8. Well Name and No.  
GALLEGOS CANYON UNIT 58

BP requests to P&A the subject well. Please see the attached P&A procedure including wellbore diagram and the required reclamation plan documents.

## PLUG AND ABANDONMENT PROCEDURE

CONDITIONS OF APPROVAL

## Proposed P&A

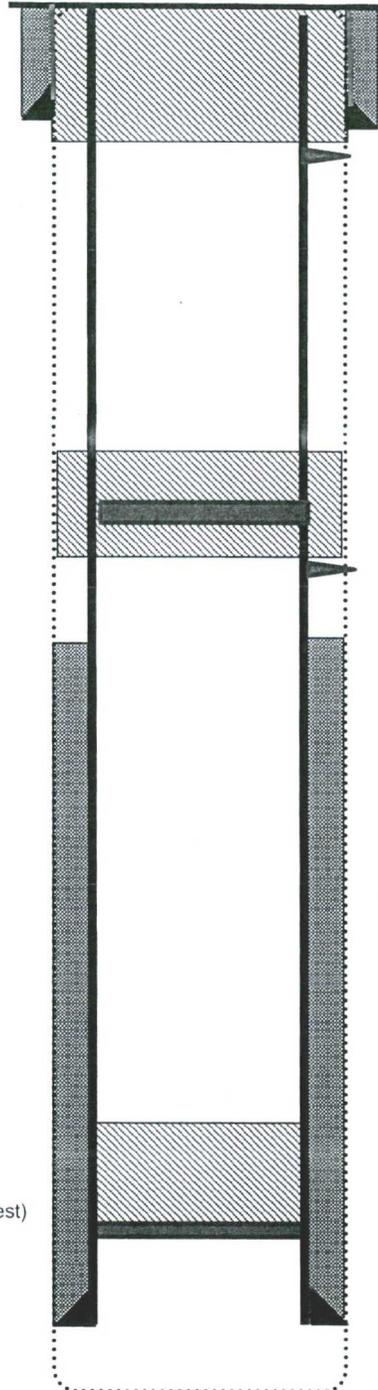
- a) Set Plug #2 (1500 - 1400) ft. inside/outside to cover the Fruitland top. BLM picks top of Fruitland at 1450 ft.
- b) Add a cement plug (674 – 467) ft. inside/outside to cover the Kirtland top and the Ojo Alamo interval. BLM picks top of Kirtland at 624 ft. BLM picks top of Ojo Alamo at 517 ft.

Operator must run a CBL to verify cement top. Submit the electronic copy of the log for verification to the following addresses: [aelmadani@blm.gov](mailto:aelmadani@blm.gov). [brandon.powell@state.nm.us](mailto:brandon.powell@state.nm.us)
